## City of Sebastopol Design Review Board Staff Report

Meeting Date: May 20, 2020  
Agenda Item: 6b  
To: Tree Board  
From: Alan Montes, Associate Planner  
Subject: Tree Removal Permit  
Recommendation: Approval with Conditions  
Applicant/Owner: David Fowler (Applicant)/Carol Rogers (Property Manager for HOA)  
File Number: 2020-027  
Address: 8301 + 8311 Valley View Court  
CEQA Status: Categorical Exemption: Section 15304: Class 4  
General Plan: High Density Residential (HDR)  
Zoning: Planned Community (PC)

**Exhibit A**  
**TREE REMOVAL PERMIT**  
**8301 + 8311 Valley View Court**  
**Removal of Protected Trees**

ARBORIST'S REPORT  
8301-8311 Valley View Ct - Sebastopol  
April 6, 2020

- VALVE/ZONE NUMBER
- FLOW RATE (GALLONS PER HOUR)
- ZONE AREA IN SQUARE FEET
- VALVE SIZE

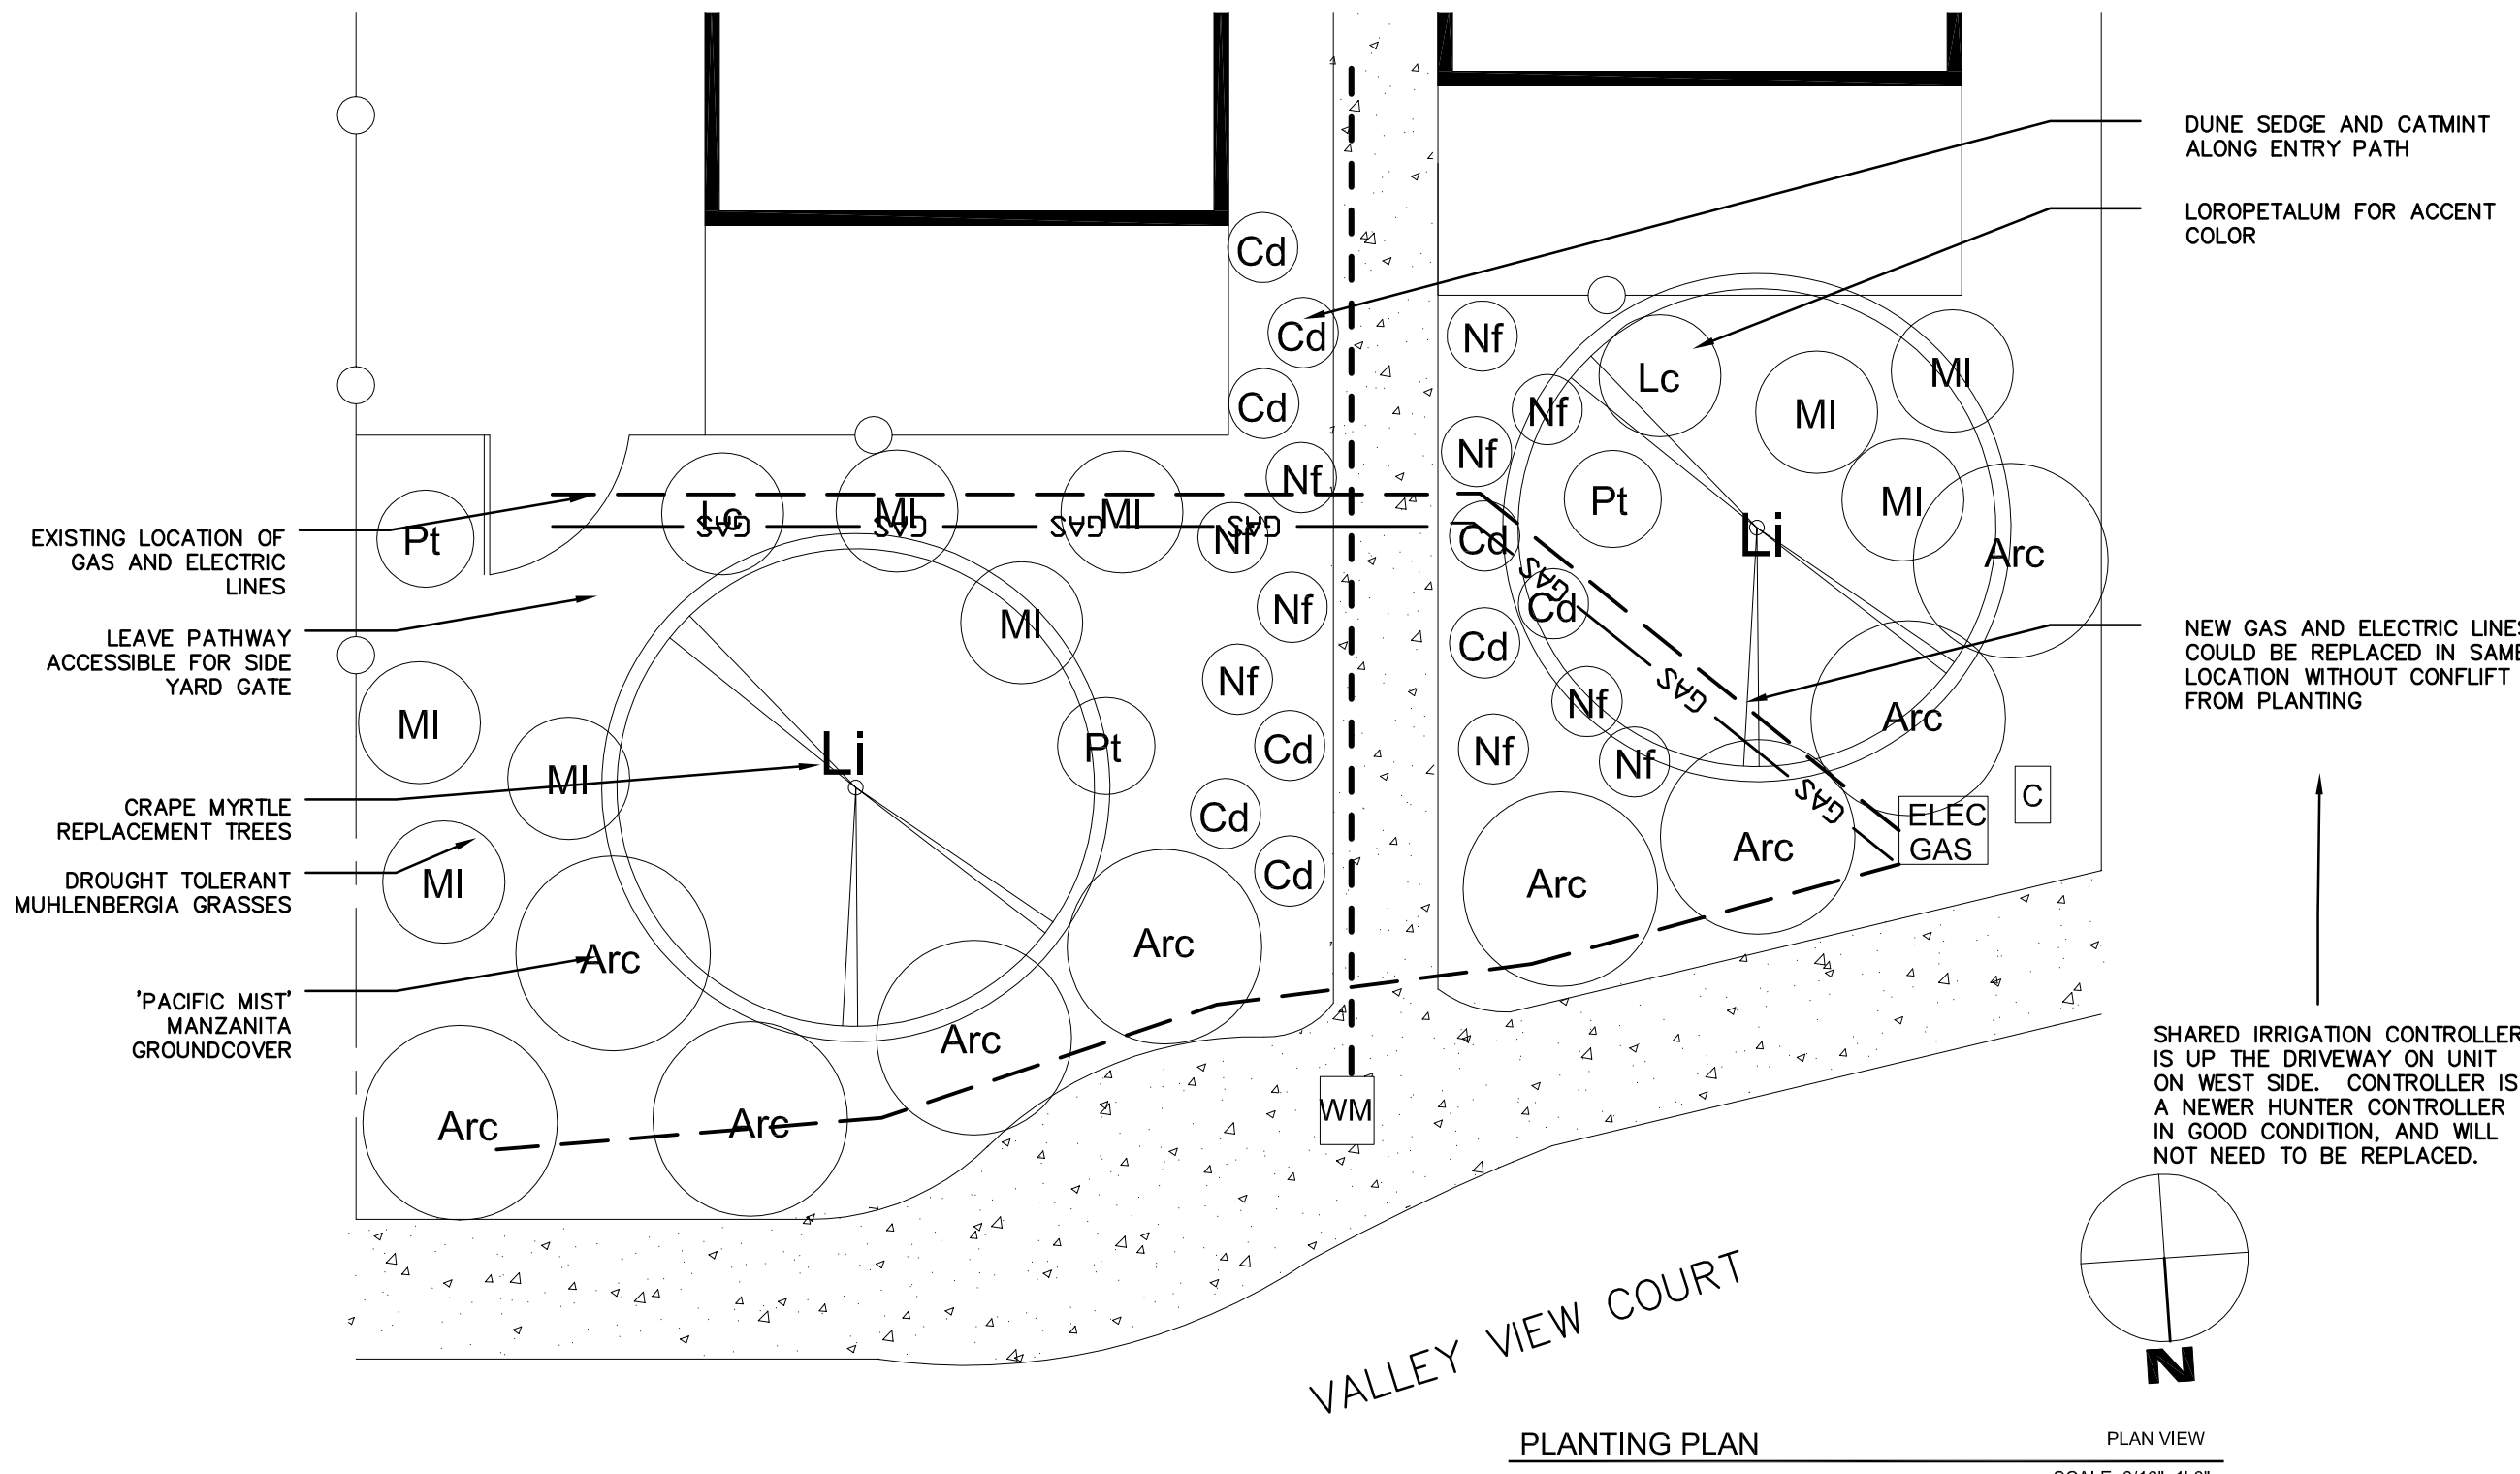
I visited this site on April 2nd at the request of the Planning Dept. to evaluate six coast redwoods (*Sequoia sempervirens*) growing in small planter areas at Green Valley Vista on Valley View Dr.. All six trees are proposed for removal. There are other large redwoods in similar locations in this townhouse complex, though these are the only ones being proposed for removal right now.

They are growing in front of two of the units, 8301 & 8311 Valley View Ct. Roots from all six redwoods have already visibly caused damage to the adjacent sidewalk (which has been repaired), as well as growing into the utility boxes and lines mentioned in David Fowler's report.

I agree that these trees are a species that is inappropriate for these confined spaces. Landscape architects in the '80's had different concepts of tree selection and growth than informed ones do now.

In regard to replacements, one of the main goals of Sebastopol's Tree Ordinance is to protect trees in the community which provide valuable assets such as shade, privacy screening, etc. The proposed replacement trees are Catawba crape myrtle (*Lagerstroemia indica* 'Catawba'). This shrubby smaller crape myrtle species is susceptible to powdery mildew (a fungal disease) in this area. I agree that large shade trees would grow too large for the spaces proposed, but I recommend specifying a larger crape myrtle. Any of the hybrids with names such as Natchez and Muskogee are larger and upright (when trained properly) and will be closer to 25' in height when mature – an appropriate size for these locations.

As far as the requirement for a 1:1 replacement instead of Sebastopol's 2:1, I think it makes sense on this site with tight spaces but the City will probably require in-lieu fees for the trees not installed. You can discuss that with staff.
